Steeple Renewables Project

Applicant Response to Written Representations and Other Documents Submitted at Deadline 1

Document Reference: EN010163/EX/8.10

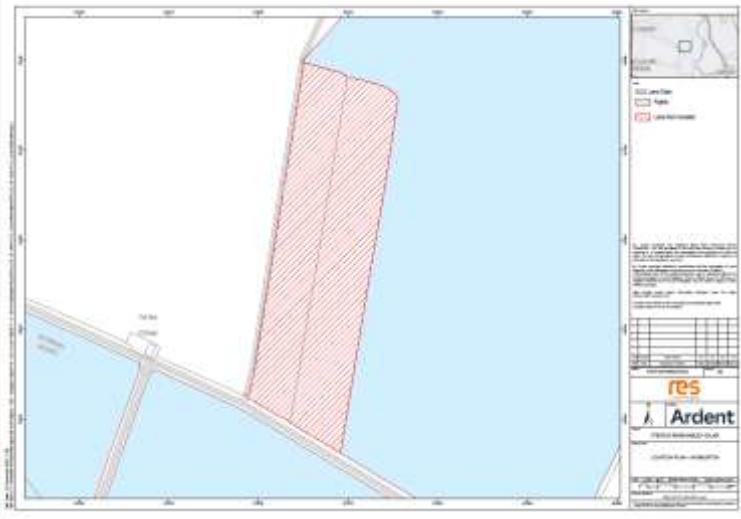
ID	Theme	Verbatim Comment	Applicant Response
REP1-038/1	Background	Background: I have lived in Sturton le Steeple all my life, and farmed there since I left school in the early 1960s. I have been a member of the parish council for 36 years, and served several years as chairman. I am now retired, so apart from my co-ownership of a small parcel of land, do not have any direct involvement with the soil, but am appalled by the proposed desecration of good land.	Please see the Applicants common response E (Use of Best Most Versatile Land) found on pages 285-286 of the Applicant Comments on Relevant Representations [REP1-008].
REP1-038/2	Woodland/ Compulsory Purchase	My Objection: This is purely a personal point, and involves the small parcel of land that I own, jointly with my brother, XXX. The field in question has been in our family for several generations, and on our retirement, a few years ago, XXX and I arranged with the Sherwood Forest rust and the Woodland Trust, to plant the field with trees. This was accomplished in January 2022, and there is a very high success rate of young saplings, they are currently between 4' and 6' tall. The agent of the land-owner behind this RES project has previously tried to buy our field, which stands like an island in the middle of Area D, Land	<p>It has been separately confirmed to the author of this response that no plot of land they own is included within the Order Limits of the Proposed Development and will not, therefore, be the subject of any Compulsory Acquisition (CA) powers. This is also confirmed on page 326 of the Applicant Comments on Relevant Representations [REP1-008].</p> <p>Please see plan on following page that shows Mr Warburtons land (red hatching) outside of the Order Limits (blue).</p>
